No. CF-91-38

AIRWORTHINESS DIRECTIVE

CF-91-38 DE HAVILLAND

Applies to all Boeing Canada, de Havilland Division Model DHC-1 Chipmunk aircraft.

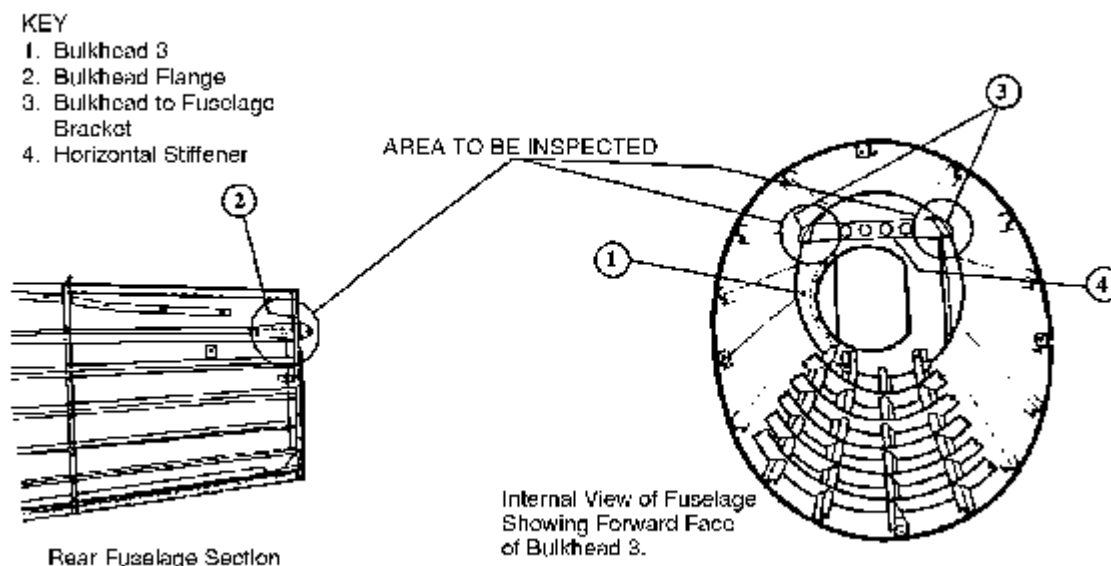
1. All aerobatic and glider towing flights are prohibited until an initial inspection per paragraph 2 of this directive has been completed.
2. Within ten (10) flight hours following the effective date of this directive, unless already accomplished within the previous 12 months, inspect the fuselage rear bulkhead for cracks as follows:
 - a) Remove the tailcone and gain access to the forward face of bulkhead No. 3 by removing the "D" cover plate covering the bulkhead lightening hole.
 - b) Locate the upper horizontal stiffener and brackets between the bulkhead and the fuselage (see accompanying illustration).

- c) Thoroughly clean the area around the stiffener brackets and the bulkhead flanges.
- d) Using a borescope with a flexible probe or a 10-power magnifying glass and a strong light, inspect the stiffener flange base, the bulkhead flange, the bulkhead-to-fuselage brackets on the forward face of the bulkhead and the area around the tailplane brackets in the aft face of the bulkhead for signs of cracks.
- e) If cracks are found, repair the cracked components before further flight.

3. Repeat the inspection per paragraph 2 at intervals which are to be determined as follows:

- not exceeding 12 months or 200 flight hours, whichever occurs first, for original bulkheads; or
- not exceeding 36 months or 600 flight hours, whichever occurs first, for repaired or replacement bulkheads.
